This drawing is issued for customer approval. please review, make approval changes (if any) in red. check the appropriate box, sign & date.

US SUGAR CORPORATION
PRIMARY SCREENED JUICE TANK C
△1 EQUIP. #RJH TNK 100239
CUST. PO #4500440583

DRAWING NO.: 021-26-1 SHT 1 OF 5 REV. SET 1

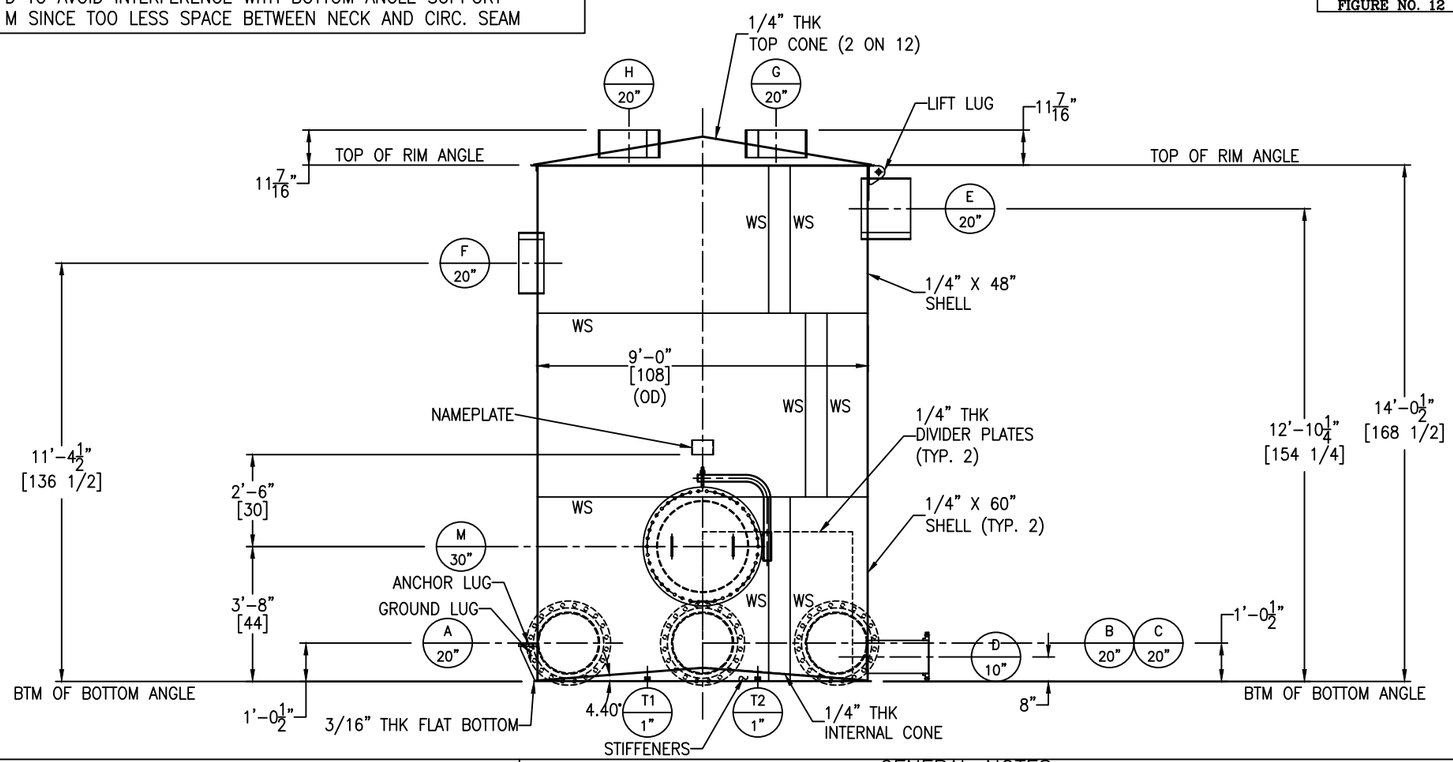
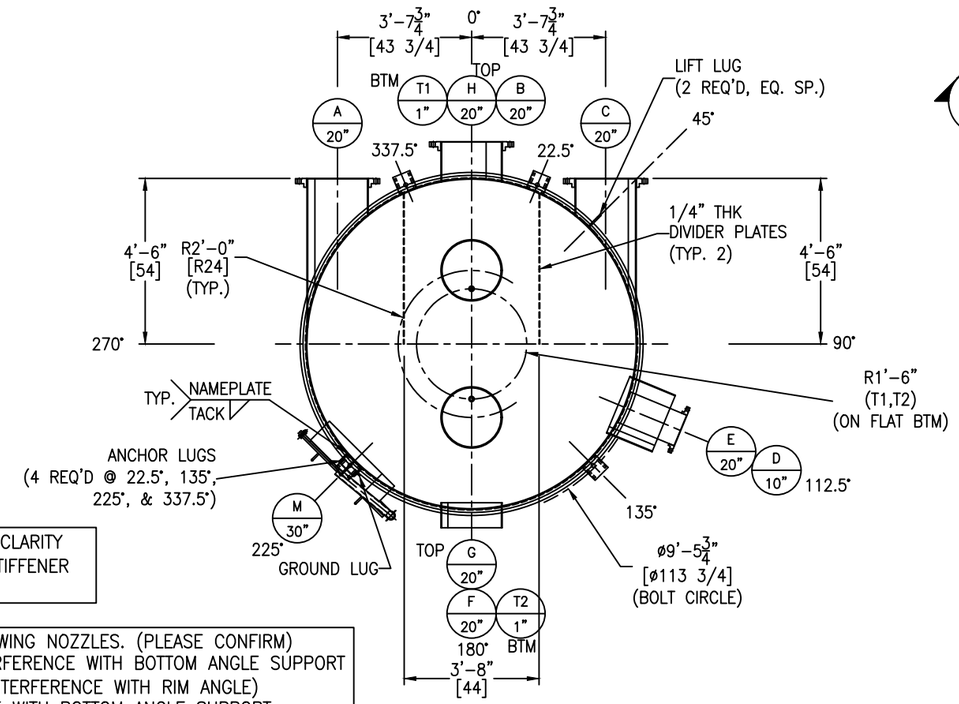
ELEVATION CHANGED FOR FOLLOWING NOZZLES. (PLEASE CONFIRM)
1. A, B & C TO AVOID INTERFERENCE WITH BOTTOM ANGLE SUPPORT
2. E (OVERFLOW TO AVOID INTERFERENCE WITH RIM ANGLE)
3. D TO AVOID INTERFERENCE WITH BOTTOM ANGLE SUPPORT
4. M SINCE TOO LESS SPACE BETWEEN NECK AND CIRC. SEAM
